NOTICE
PLAN COMMISSION
April 21, 2015

TO: Plan Commission
FROM: Tom Hovel, Zoning Administrator/City Planner
Susan Badtke, Community Planner
DATE: April 16, 2015
SUBJECT: April 21, 2015 Plan Commission Items

Application: ADR
Property Address: 5898 Adams Road
Property Location: Lot 1 CSM 12880
Review Date: March 24, 2015
Planning Staff Review #1

Application: PP-2054-15
Property Location: Lot 2 CSM 9896
Review Date: April 8, 2015
Planning Staff Review #2

SHEET NUMBER:
C1.0

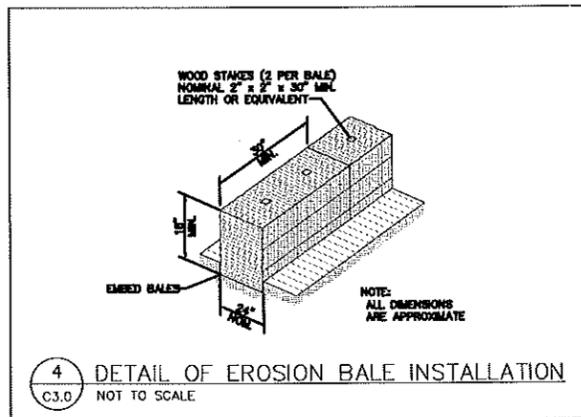
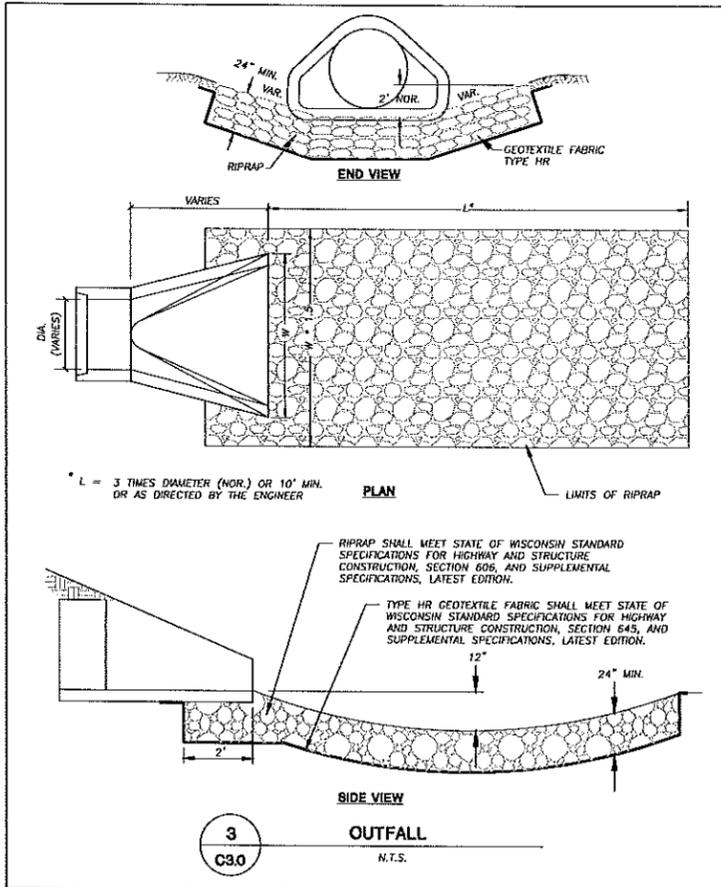
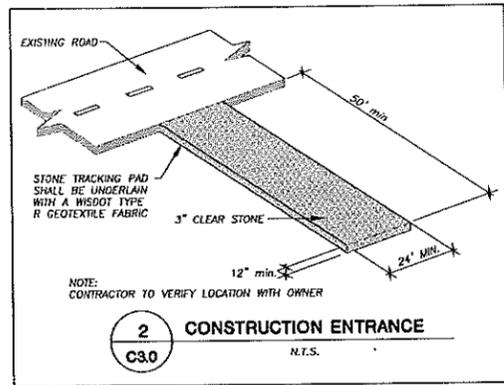
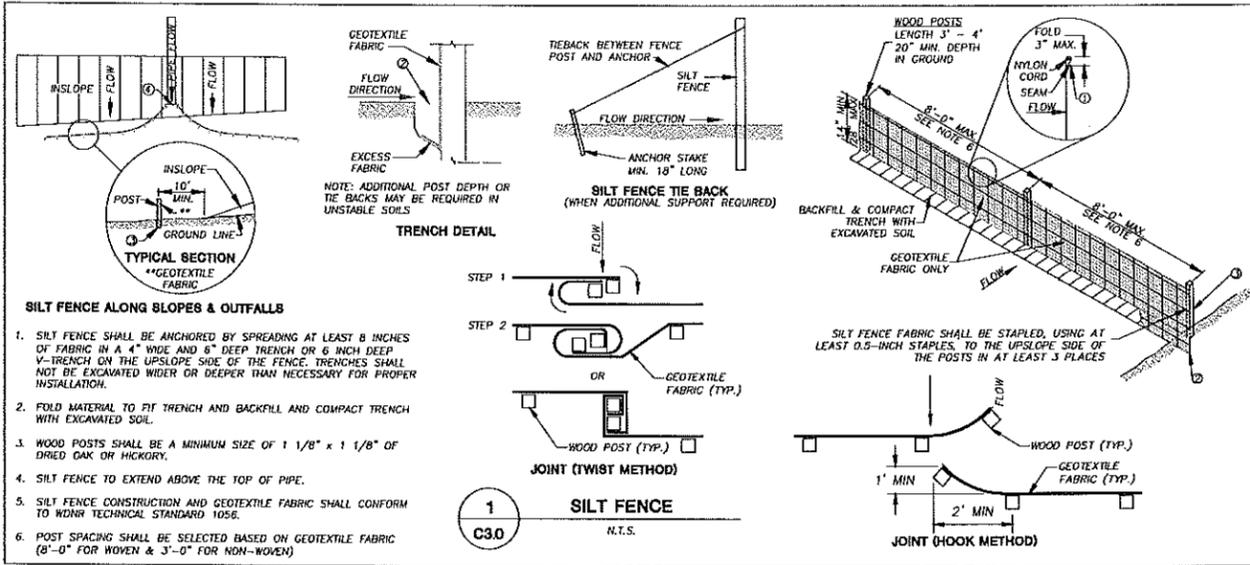
- 1.) Please provide a site plan that includes dimensions of the proposed structure and the distances from the property lines. **We have JSD doing a new site and erosion control plan. Hope to have it completed by Monday**
- 2.) The "future addition" will require future approvals. **We are making building larger now and not doing a future addition.**
- 3.) The proposed use is listed on the application as "Ag". Please provide a more detailed description of the proposed ag use. **Frostwood Farms produces hay for area horse stables . This building will be used for storage of hay and hay making equipment.**
- 4.) Fire Department has asked you to confirm that this building is for private use; please confirm. **Frostwood Farms produces hay for horses and has two other hay barns located on Cane Road and Fitchburg Road. Yes they are used for private hay storage.**

SHEET NUMBER:
C2.0

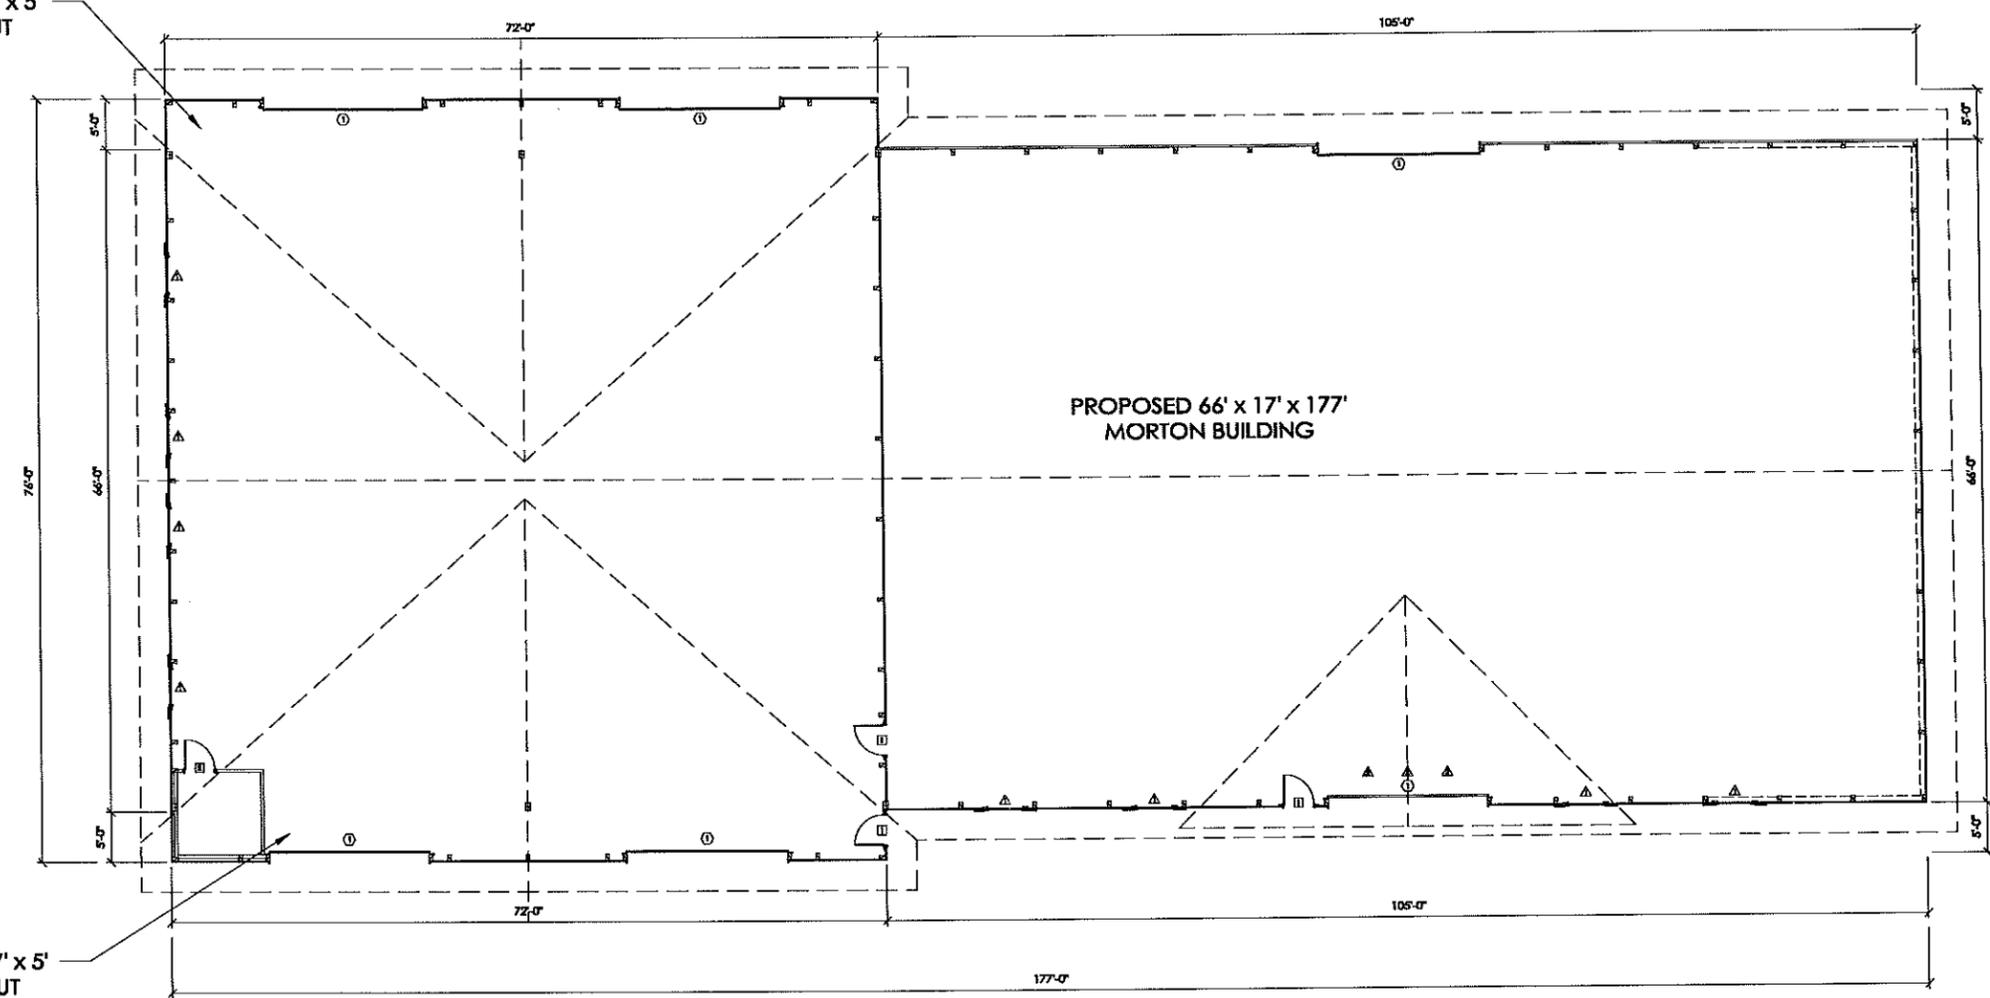
Sheet C2.0 shows the proposed building location overlaid on an air photo. According to the applicant, the area where the owner wants the new building is a low area that is always wet and shaded by trees. It is a low area that they will build up for drainage and turn the area east of the building into prairie restoration. Sheet C2.0 Grading and Erosion Control Plan, shows the area that will be created into a prairie east of the building. Per the application this is a rocky slope that was corn last year. All of the wooded area on the farm is mostly side hill. The applicant feels this is the least disruptive area for a building on the farm.

Additional PW Comment 2: Sheet C2.0 was received on April 9, 2015.

The plan appears to have a well thought out stormwater conveyance and treatment approach; however, stormwater calculations will need to be submitted along with the ECSWM permit application noted above to confirm that the performance standards are met.

PRELIMINARY PLAT
FAHEY FIELDS
PART OF LOT 2, CERTIFIED SURVEY MAP NO. 9896 AND LAND LOCATED IN THE SW1/4 AND THE SE1/4 OF THE NE1/4 AND IN THE NE1/4 AND THE NW1/4 OF SECTION 15, T6N, R9E, CITY OF FITCHBURG, DANE COUNTY, WISCONSIN

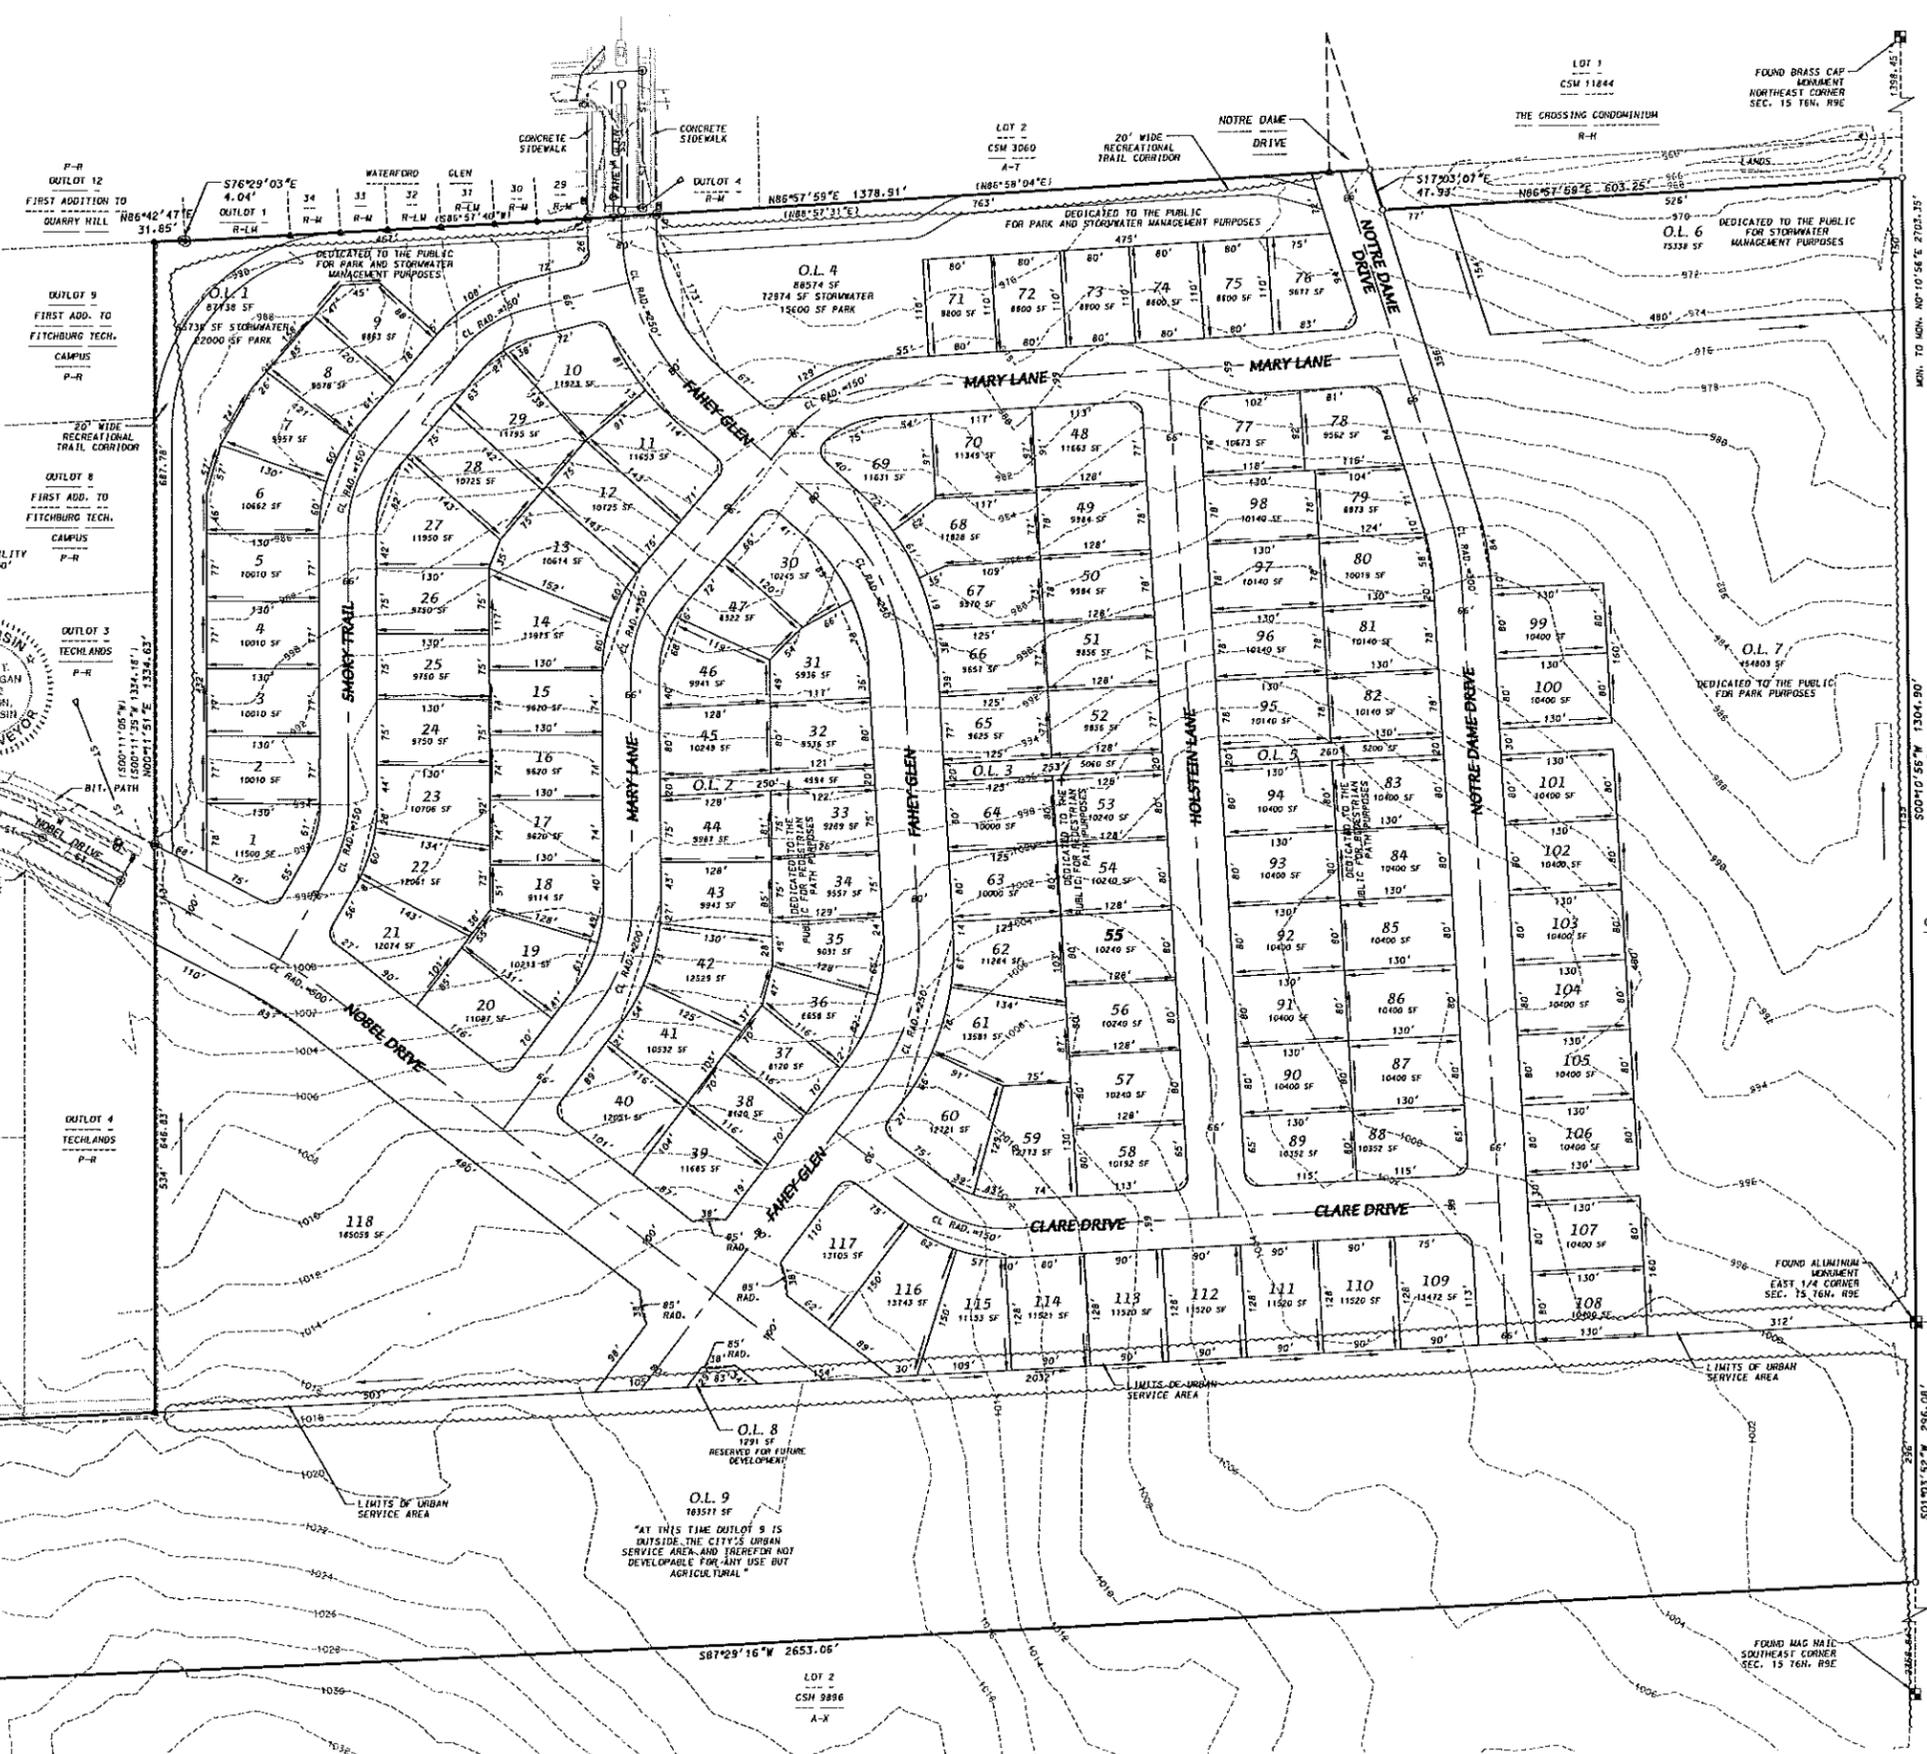
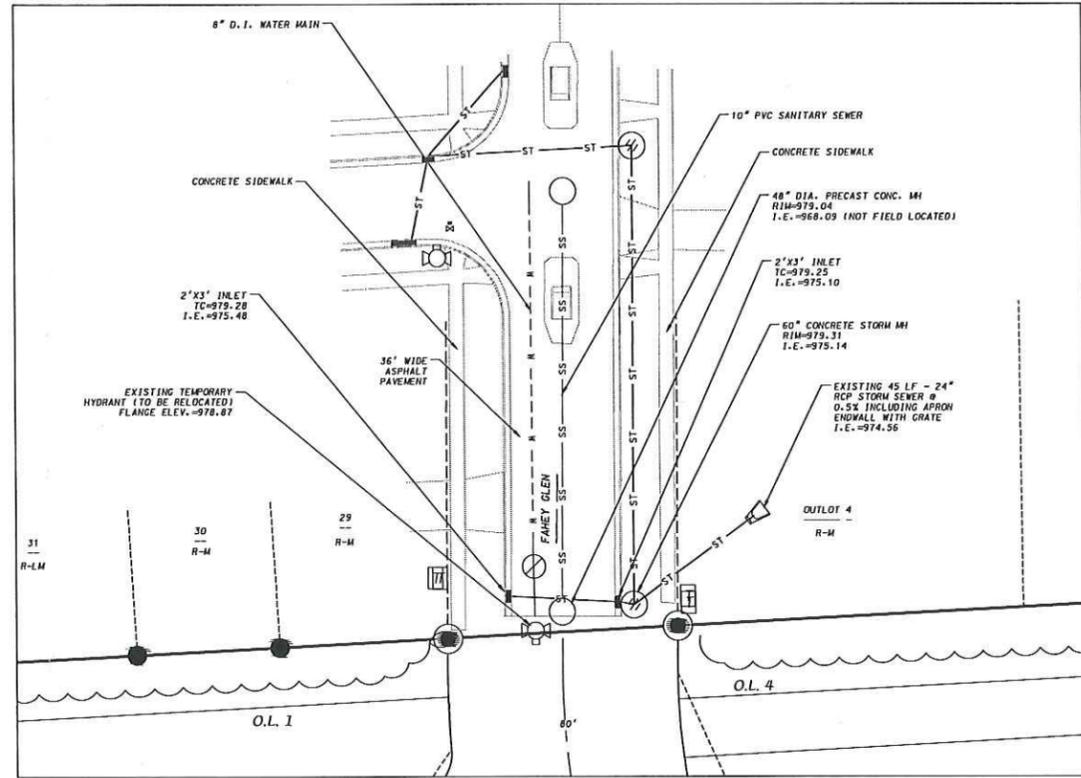
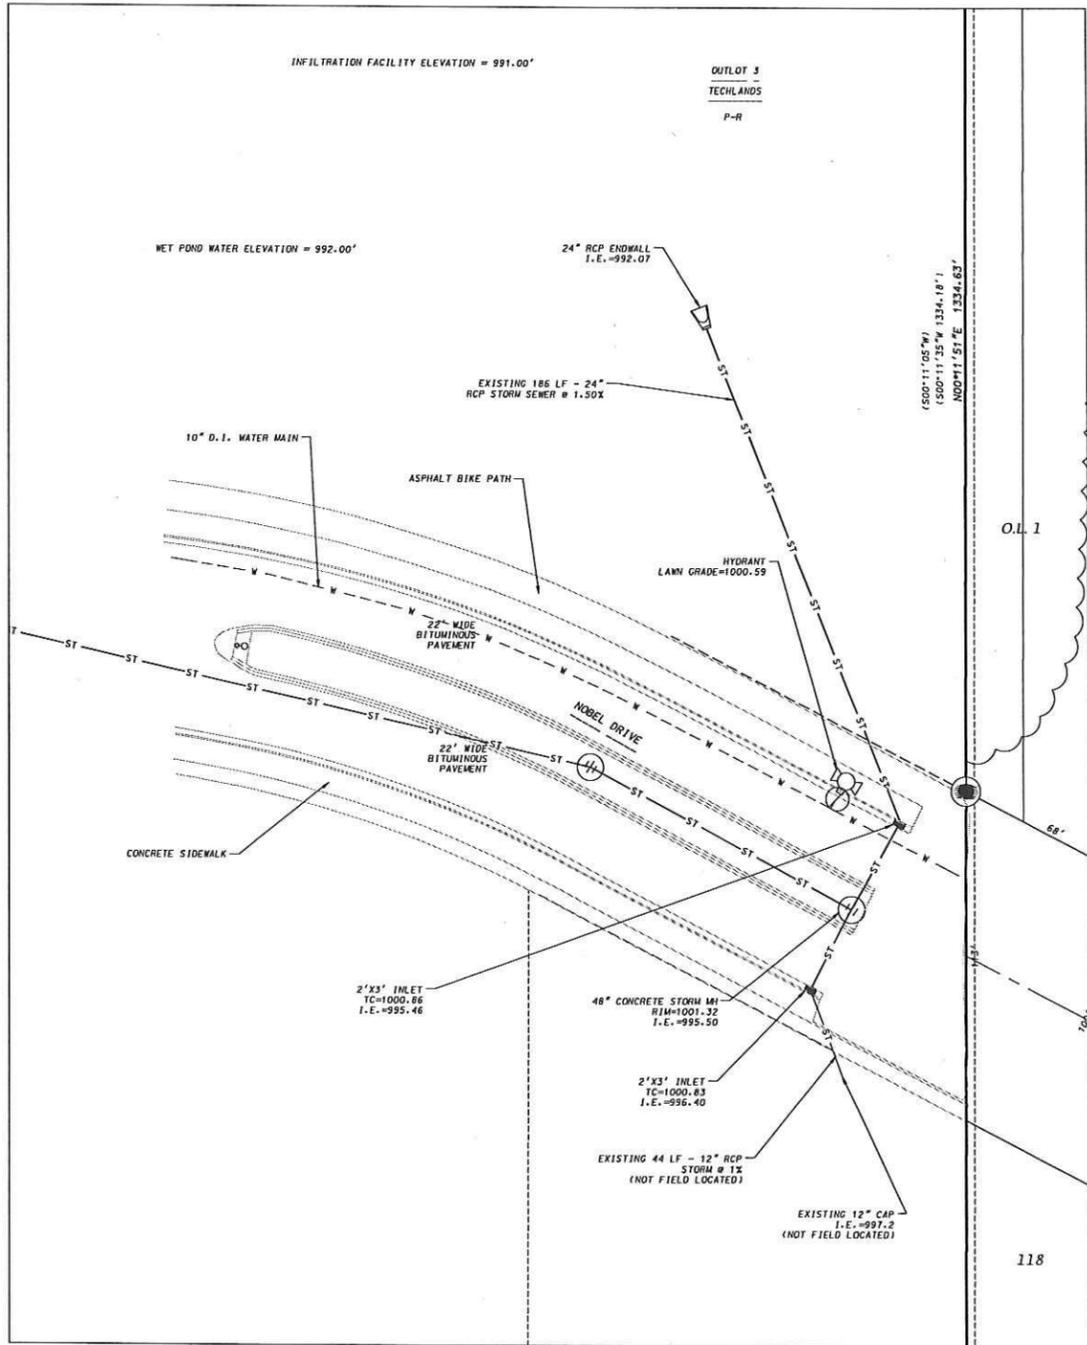
- 1.) The plan sheets are inconsistent as to the location of the wet detention and infiltration basins. The Phase Map shows the stormwater facilities fully contained in Outlot 6 while the Overall Site Plan does not show stormwater facilities on their own outlot nor are the facilities the same size and configuration as that shown on the phasing plan. Please update appropriately.
Overall Site Plan and Phase Map have been revised and updated to illustrate the size and shape of the proposed stormwater management facilities located in Outlot 6.

- 3.) The Plat was not updated to identify the areas on outlots 1 & 4 that will be for stormwater and park. Please identify what part, or size, of each outlot will be for stormwater and park and provide the area of each use for each outlot on the plat.
See revised Preliminary Plat.

- 4.) Outlots 2, 3 and 5 (paths) are shown as being dedicated over different phases. If an outlot is not being dedicated in full during a phase, it will need to be divided into two separate outlots. Please update preliminary plat appropriately.
Outlots 2,3, and 5 have been revised to be dedicated in full within one phase. See updated Phase Map.

- 5.) Areas of outlot 7 between Lots 101/102 and Lots 107/108 are shown on the phasing map as part of phase 5. These areas should be dedicated with phase 1 with the rest of outlot 7.
Acknowledged and revised. See revised Phase Map.
